Project #: 1005410 Application #: 12DRB-70158
 Project Name: Richfield Park
 Agent: Forstbauer Surveying Co LLC Phone #:

6. **Project# 1005410**
12DRB-70157 VACATION OF PRIVATE EASEMENT
12DRB-70158 MINOR - PRELIMINARY/FINAL PLAT APPROVAL 
- FORSTBAUER SURVEYING CO LLC agent(s) for JOHN E. & CYNTHIA A. MECHENBIER request(s) the above action(s) for all or a portion of Lot(s) 5-A, **RICHFIELD PARK** zoned SU-2 FOR IP OR SU-2 NC, located on ALAMEDA BETWEEN JEFFERSON AND WASHINGTON containing approximately 2.0192 acre(s). (C-17) **THE VACATION WAS APPROVED AS SHOWN ON EXHIBIT B IN THE PLANNING FILE PER SECTION 14-14-7-2(A) (1) AND (B) (1)(3) OF THE SUBDIVISION ORDINANCE. THE PRELIMINARY/FINAL PLAT WAS APPROVED WITH FINAL SIGN OFF DELEGATED TO CITY ENGINEER AND TO PLANNING.**

PROPOSED RETAIL/OFFICE BUILDINGS
 LOT 5A RICHFIELD PARK SUBDIVISION
 4545 ALAMEDA BOULEVARD N.E.
 ALBUQUERQUE, NEW MEXICO 87113

SITE PLAN FOR BUILDING PERMIT

Exhibit - Access Easement to be Vacated

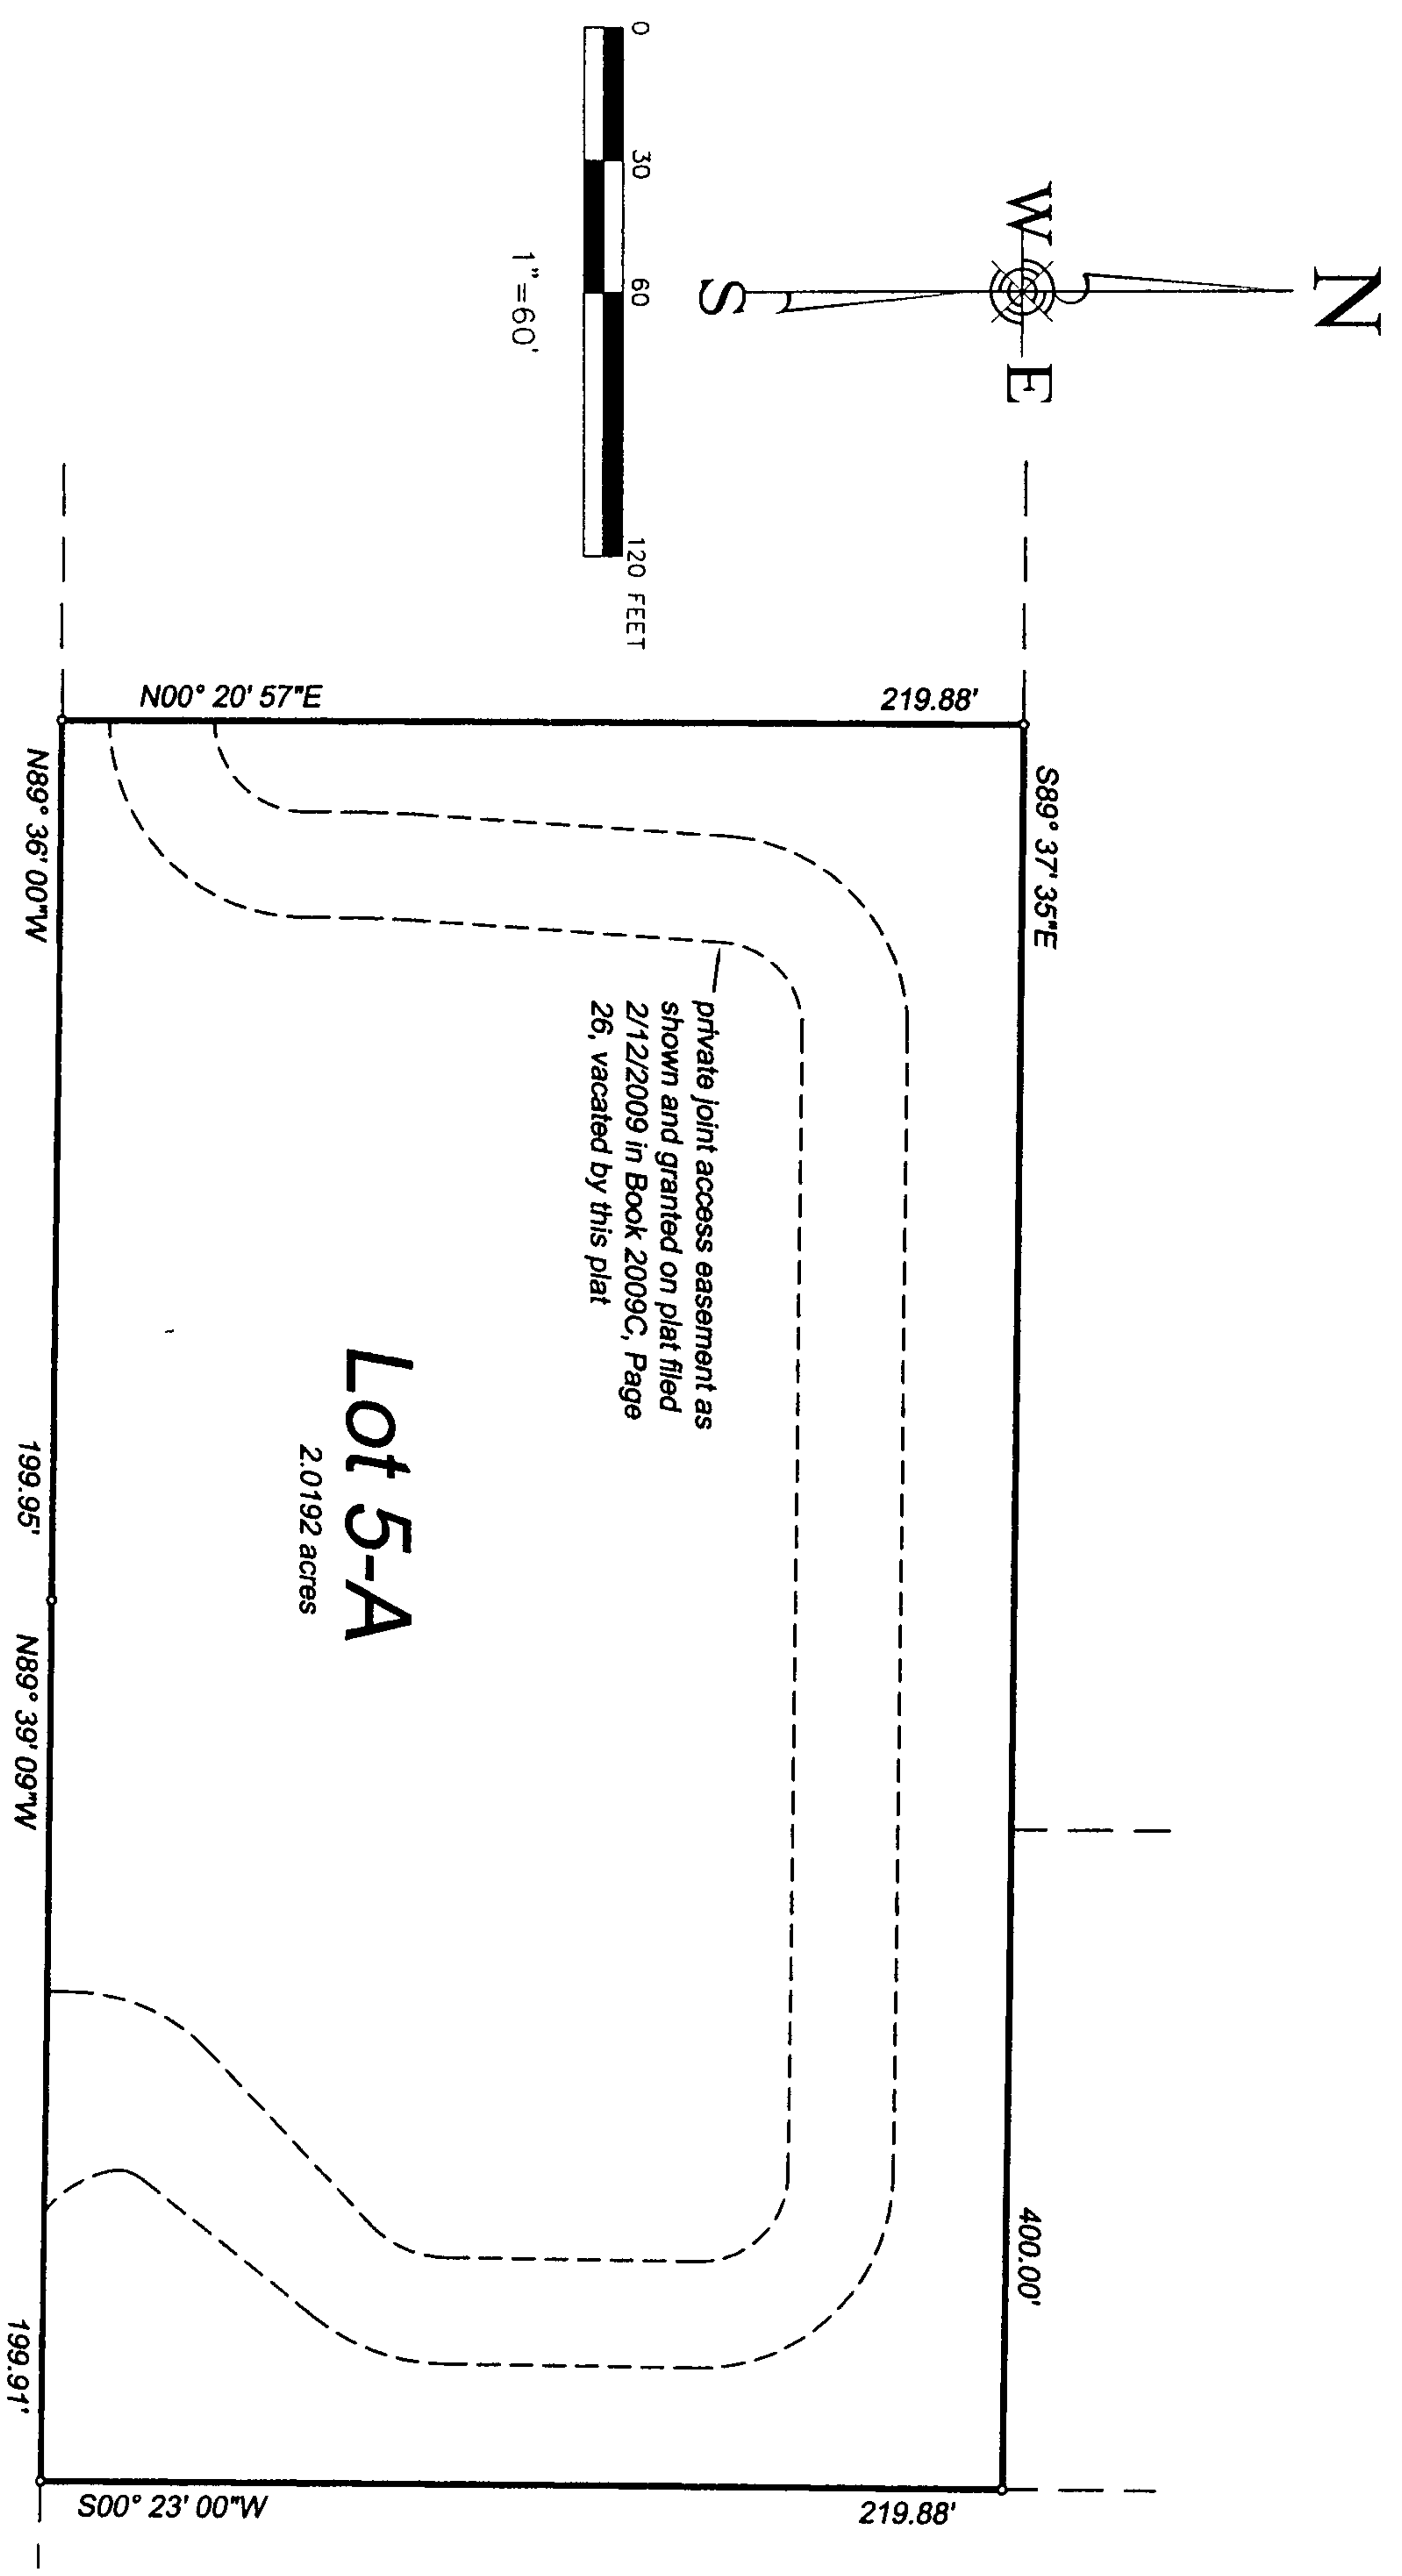
CITY ENGINEER / AMAFCA: OK clarify easement

G LIGHT POLE
1/4" = 1'-0"

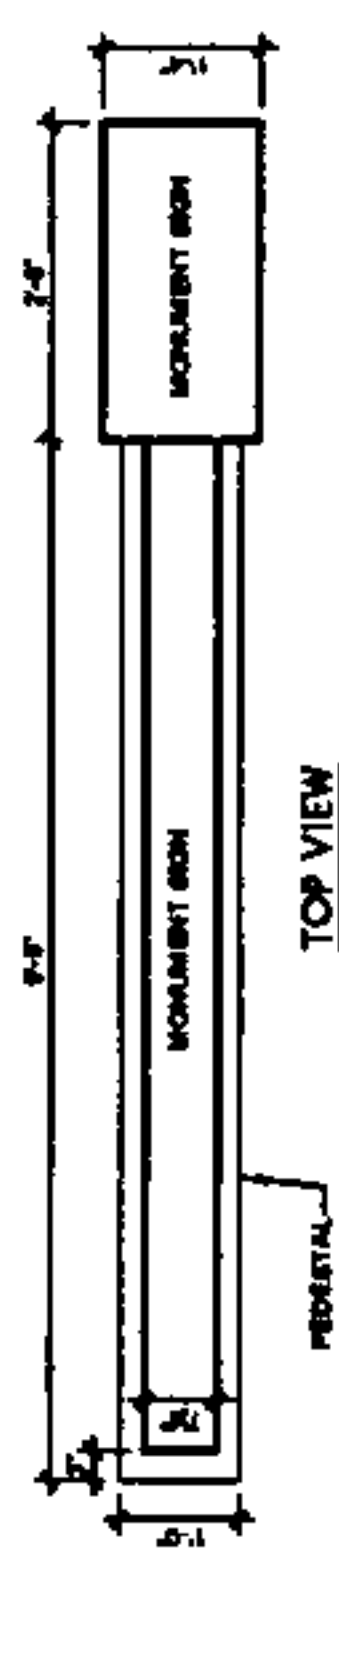
Note 52 on page shows bollard lighting. No drawing is shown on site details on page 2. Note that up lighting is not allowed as per page 33 g in the I25 sector plan.

H MONUMENT SIGN (TWO SIDES SIMILAR)
1/4" = 1'-0"

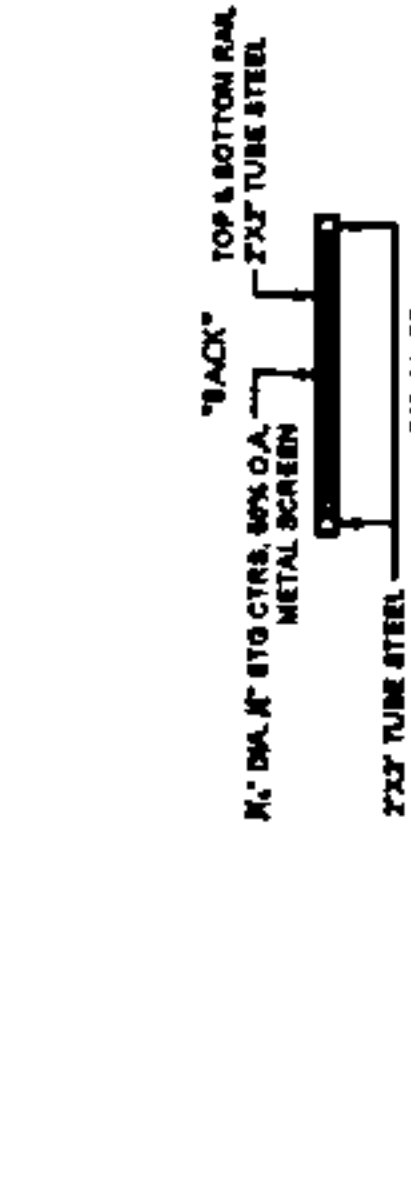
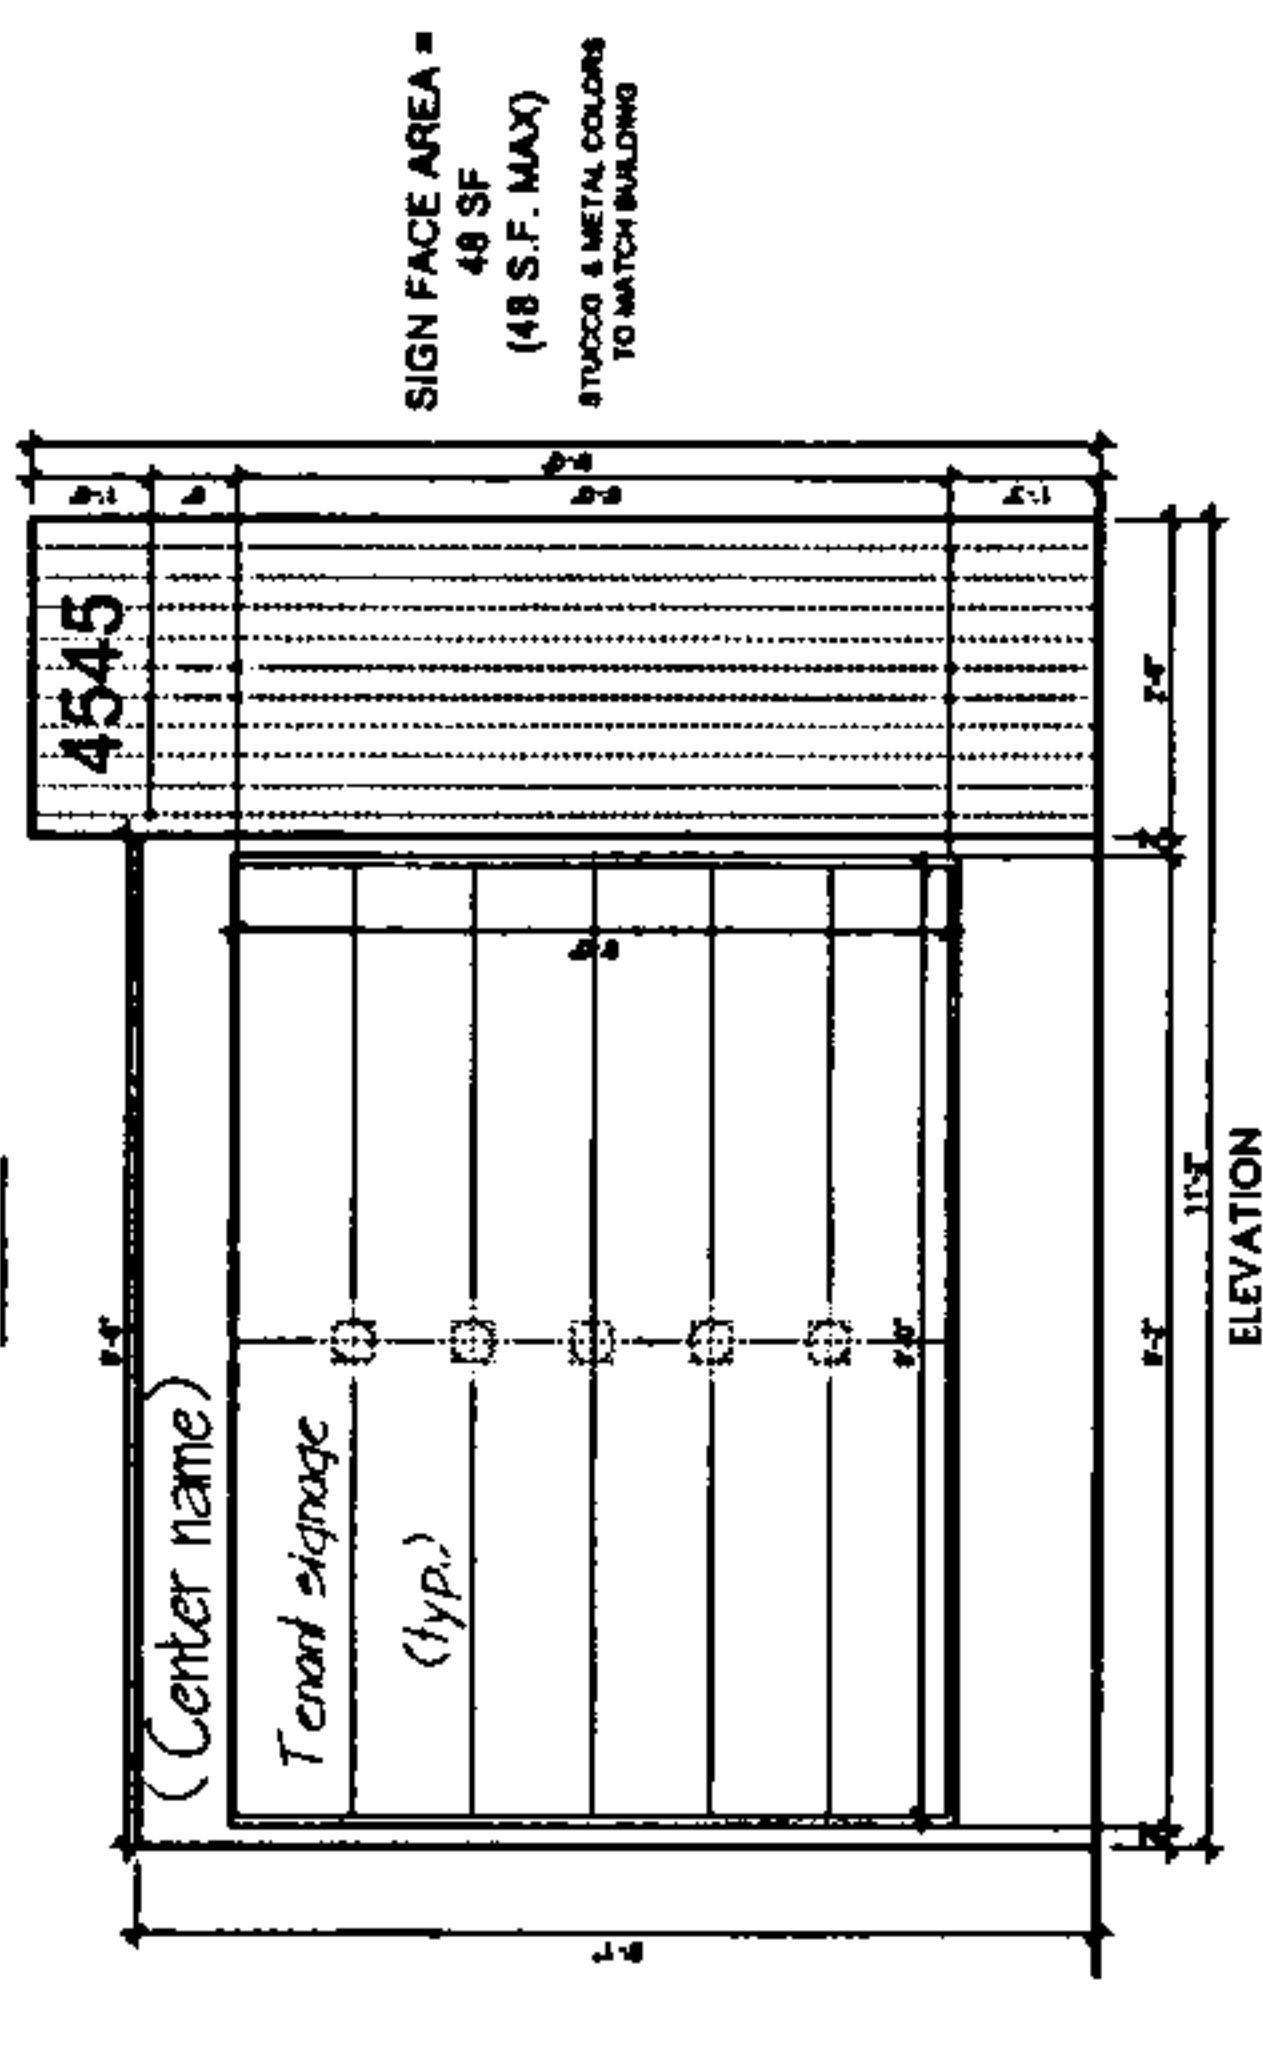
The site plan shows 2 monument signs. 1 is allowed as per page 37 of the North I 25 plan.
